Relay Board Assembly (0521B-000)

FOR USE WITH MODELS: CV-350, CV-350C,
CV-353, CV-353C

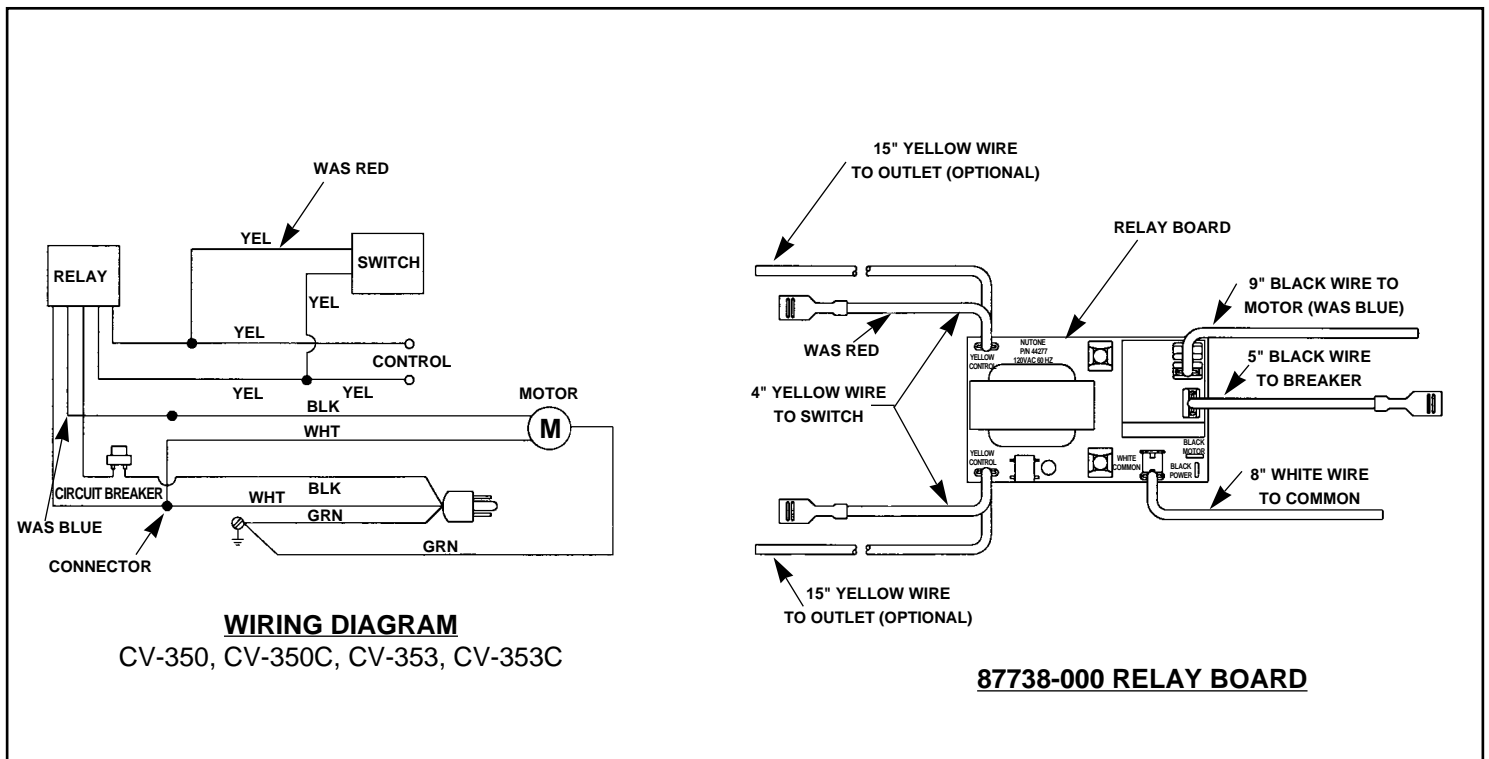
The relay assembly you are replacing may not have the same wire appearance as the new assembly. Please note the following changes:

1. The blue power lead wire has been changed to a black lead wire.
2. The red lead wire connected to the switch has been changed to a yellow lead wire.
3. For models manufactured after May 1997, two additional yellow lead wires are provided. If your power unit was manufactured prior to May 1997 and if these lead wires are not used either remove each lead from the terminal connection or cap each lead wire with an appropriate size wire nut.

Warning: Disconnect electrical supply before servicing unit. Failure to do could result in serious injury or death. Disconnect old lead wires and reconnect per the wiring diagram below.
